Work Order ID 74901

Item Name: Replacement Skidtube

DRAWING NO. D2580	TITLE 205 SKIDTUBE ASSEMBLY	REV. E	DART AEROSPACE LTD ENGINEERING ORDER	D.E.O. NO. D2580-E-1	SHEET NO. SHEET 1 OF 1	SCALE NTS
DRAWN <i>JP</i>	CHECKED <i>ASS</i>	MFG. APPR. <i>EC</i>	APPROVED <i>[Signature]</i>	DE APPR. <i>[Signature]</i>		
DATE 11.12.13	DATE 11.12.13	DATE 11.12.13	DATE 11.12.13	DATE 11.12.13

CHANGE ALL C'BORED WELDED CROSSBOLT SPACERS TO SWAGED SPACERS

SECTION B-B
SCALE 5X

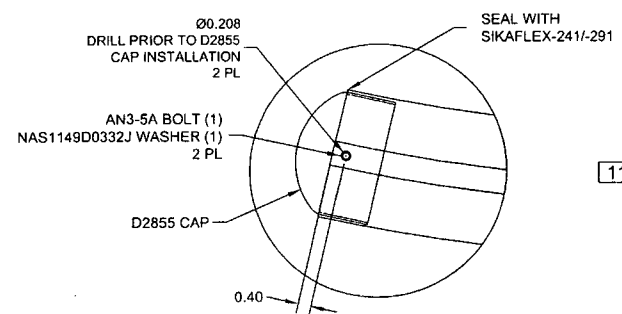
SECTION B-B, SECTION F-F, & SECTION I-I ARE AMENDED AS FOLLOWS FOR ALL HOLES THAT WERE ORIGINALLY C'BORED:

1. INSERT D4202-1 SPACER, 20 PL (-041) OR 20 PL (-045) OR 25 PL (-047)
2. SWAGE TO Ø0.437 X 1.00 DEEP PER QSI 002
3. TRIM / GRIND FLUSH PER QSI 002

SECTION B-B, F-F, I-I
NOT TO SCALE

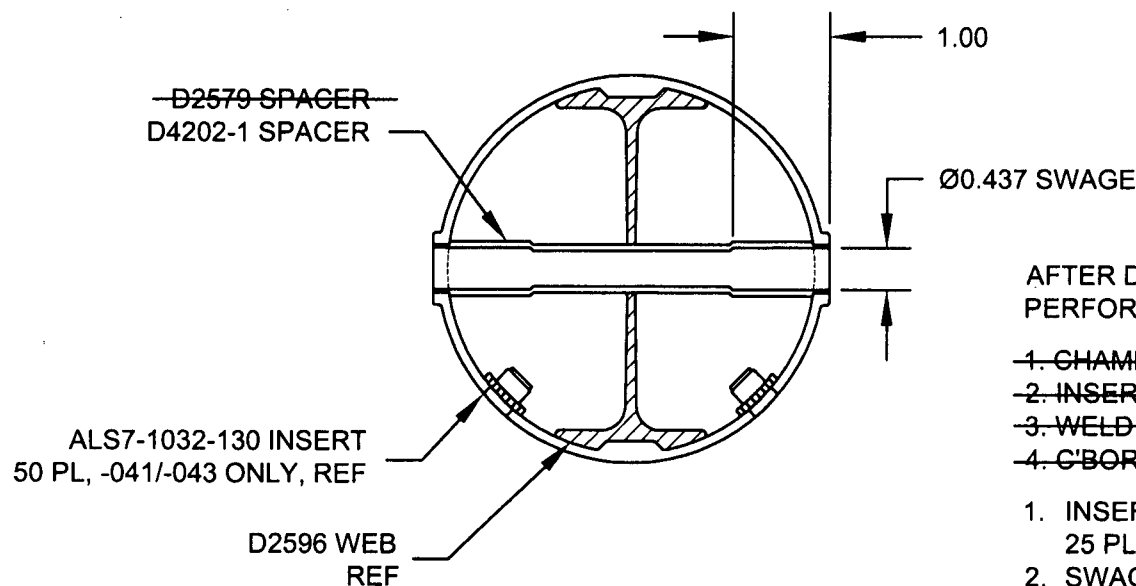
*** FOR -045 SKIDTUBE ONLY:**
WELD 4X D2579 SPACERS PER DWG
IN LOCATIONS MARKED "NO C'BORE".
REF SHEET 4 OF DWG.
